Development Review (Minor) Staff Approval

4141 Master Sign Program Amendment

Request: Request to amend the 4141 Master Sign Program to allow new mid-size monument signs, and new building directory wall signs for an existing office development.

APPROVED
Case No. 7-MS-2014#2
STIPULATION SET
RETAIN FOR RECORDS

SIGN LOCATION PLAN

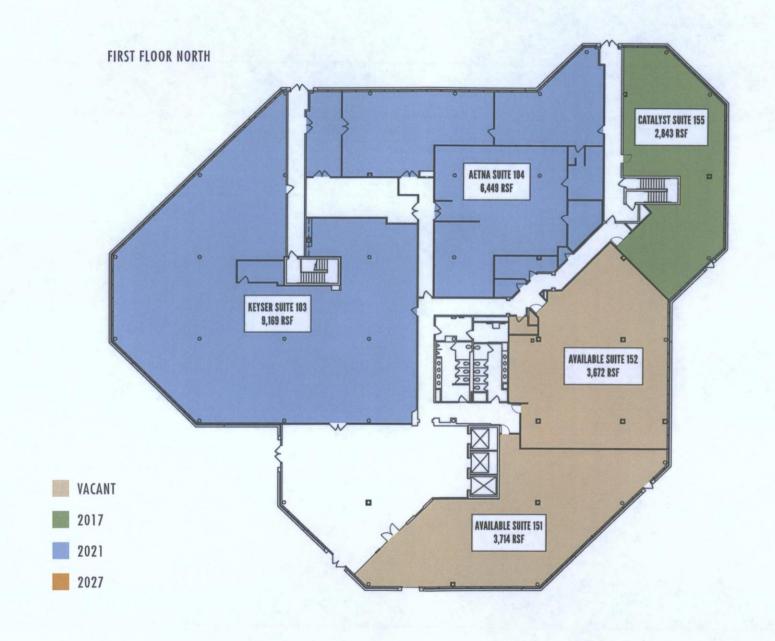
- Sign Location Plan The plan now indicates property line, existing curb, landscape and hardscape. It also shows that the existing "4141" mid-size monument sign has been assigned to Scottsdale Road frontage.
- Tenant Monuments We have reduced the illumination of the green panel features by adding a diffuser vinyl that will be applied to the inside of the translucent panels. This will create a subtle "lantern" type glow that will not overpower the glow of the tenant names.
 - O Please refer to the sample provided. We have shown the panel illuminated without the diffuser, with a 30 diffuser and with a 70 diffuser. We have called out the 70 diffuser on the drawing, which

- Building Mounted Sign Bands
- Tenant Directory
- Tenant Monument
- Existing mid-size monument (Scottsdale Rd. Frontage)
- Property Line

Tenant Monument Location Plan

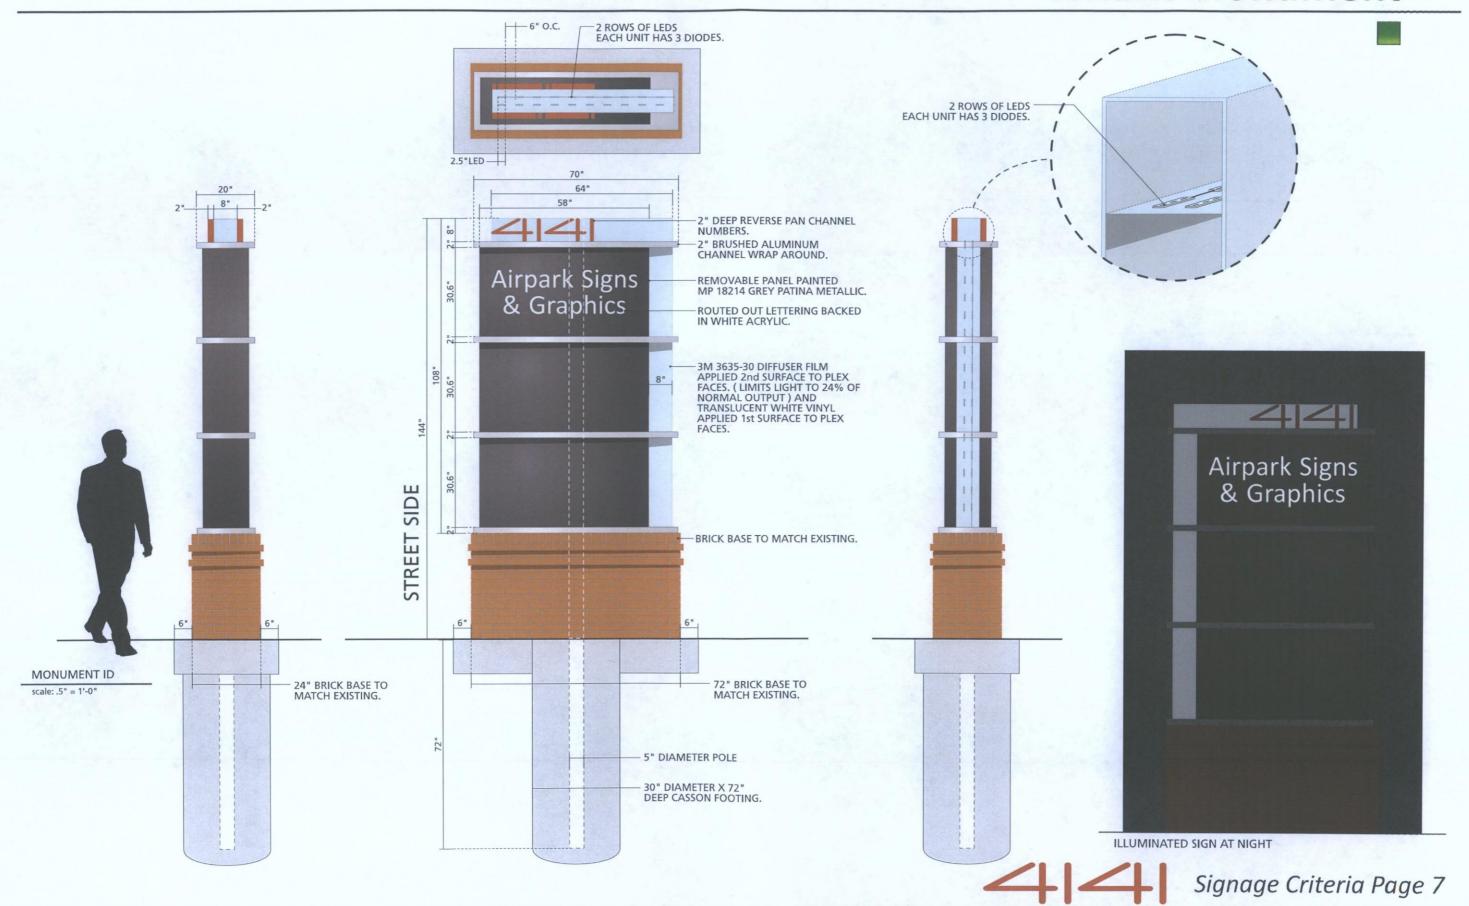
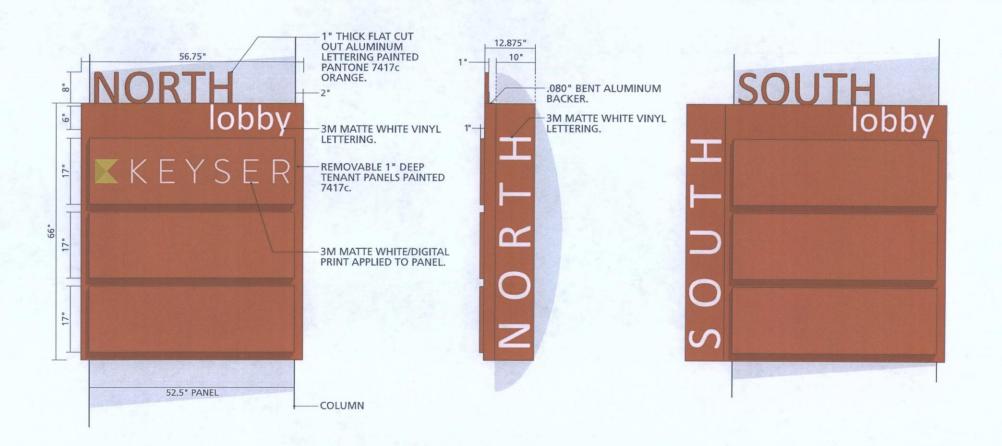
- 8. The illuminated light panels on the mid-size monument signs shall incorporate a diffuser film that will limit the light output to 25% or less of normal output, and shall evenly distribute the light across all panels to avoid hot spots, as shown on Page 7 of the 4141 Master Sign Program Amendment.

24% allows 68% output of light.

Existing Mid Size Monument

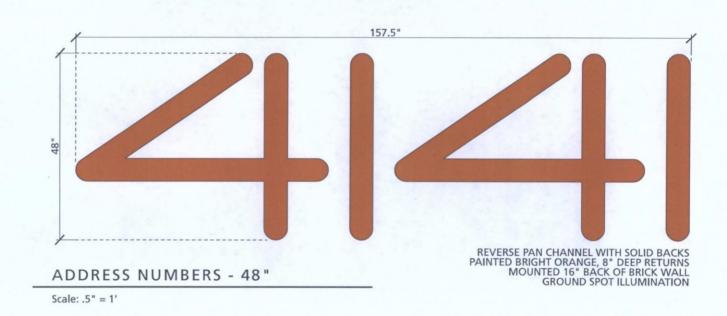
- o The existing "4141" mid-size monument is now dimensioned labeled assigned to Scottsdale Road frontage.
- Tenant Wall Directory Please refer to 2nd paragraph of this narrative for changes that have been submitted. The drawings can be referred to on page 9 of the proposed amended MSP package.
- Floor plans have been provided and are included within the proposed amended MSP package on pages 4 through 6.
